## **Planning Commission Staff Report**

**Project Type:** Site Development Section Plan

**Meeting Date:** April 9, 2012

**Description:** **Chesterfield Blue Valley, Proposed Lot 10 (Premium Outlets)**: A Site Development Section Plan, Landscape Plan, Lighting Plan, Architectural Elevations, and Architect's Statement of Design for a 50.72 acre tract of land zoned "PC" Planned Commercial District in the northeast corner of the development located on the north side of Olive Street Road, west of its intersection with Chesterfield Airport Road.

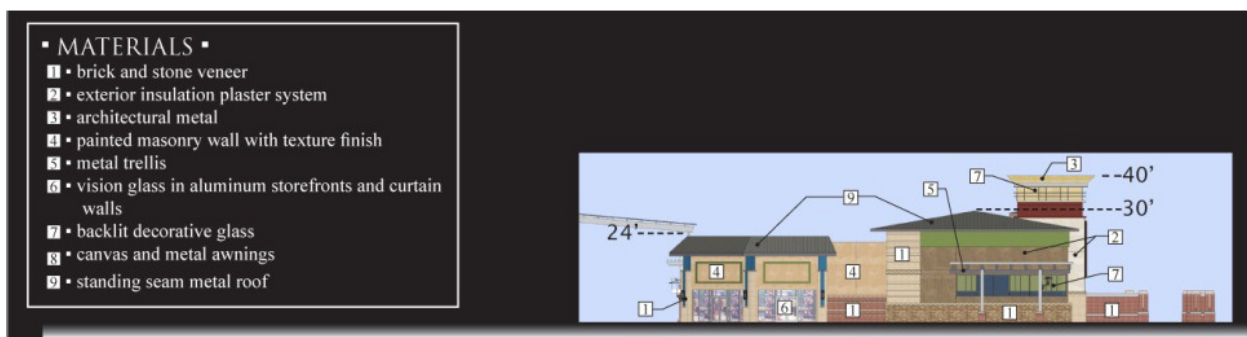
1. Consider providing additional tree coverage in the promenades.

The applicant has submitted a letter stating that they will add additional trees to the areas east and west of the Food Court area. Additionally tree locations have been identified in the main east and west pedestrian entry areas. The trees are proposed as three (3) different ornamental tree types. The plan does not need to be amended to show these locations as they are internal to the site. They will be required to be planted within the identified planter locations in the pedestrian boulevards.
